Hillingdon

Outline Fire Strategy – Rev E

OF-OFS-3671-01-E

Appendix A – Drawing Comments

3 Building 7 - Second to Fourth Floor Plan
1 : 200

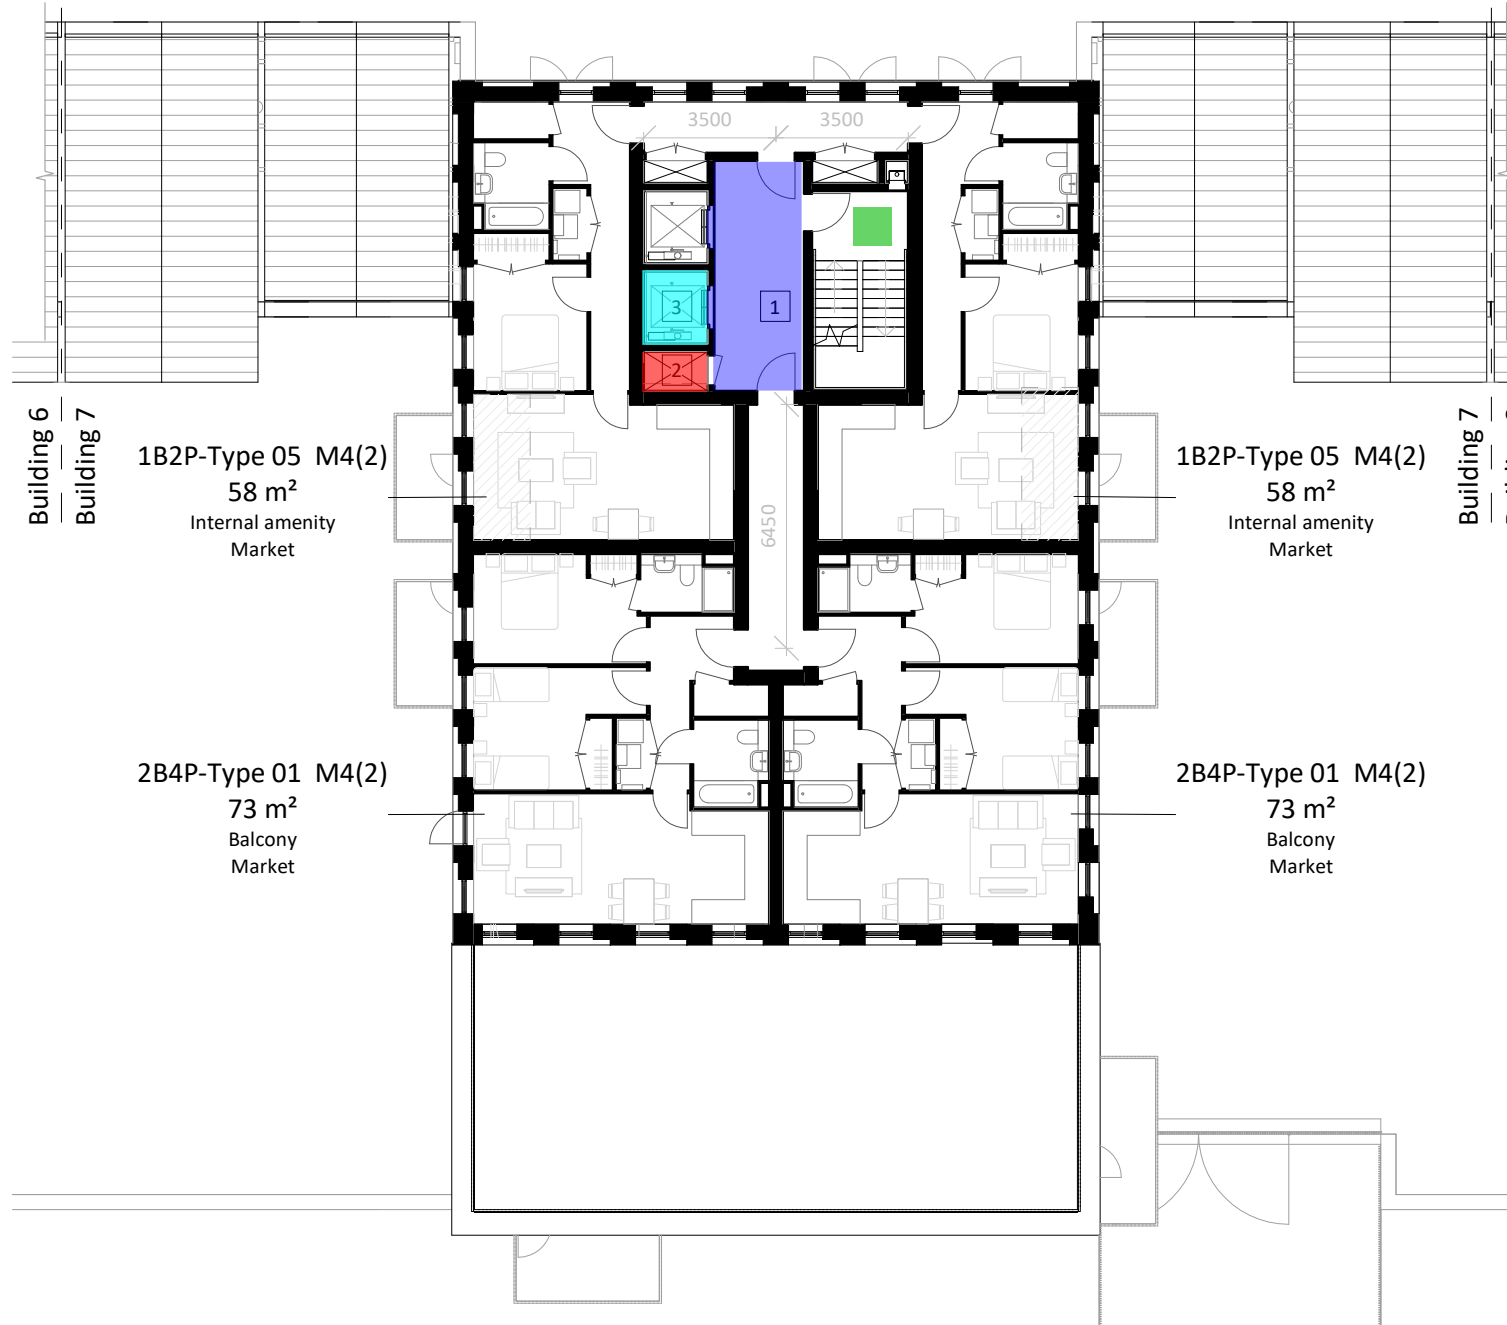
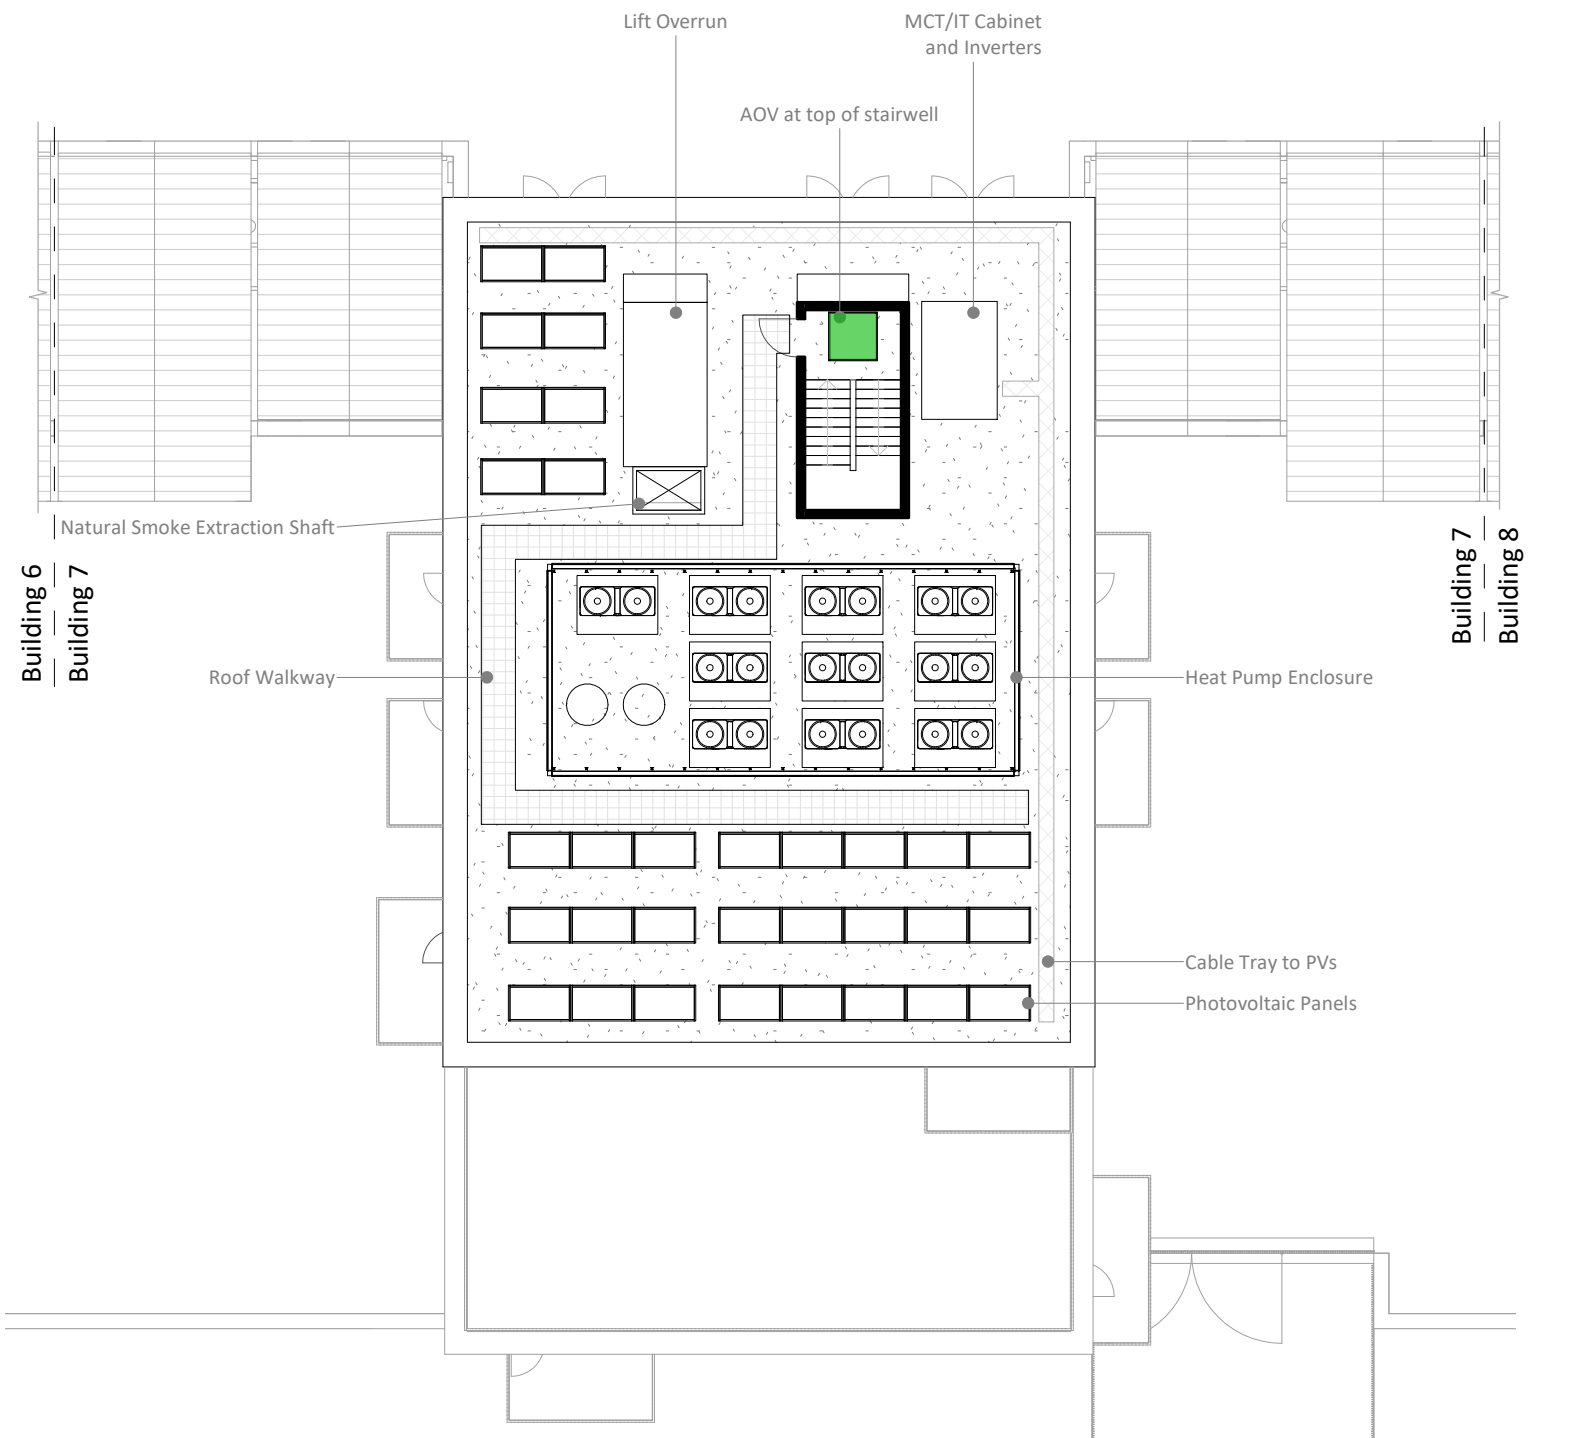
To be noted, the government have stated from May 2020, all new building's over 11m in height are required to be provided with sprinklers, see Section 9.

To be noted, if the service riser is to only contain water services or metal ventilation ductwork from the ground floor, it is considered a limited fire hazard. As such, this riser shaft may be located in the staircase lobby.
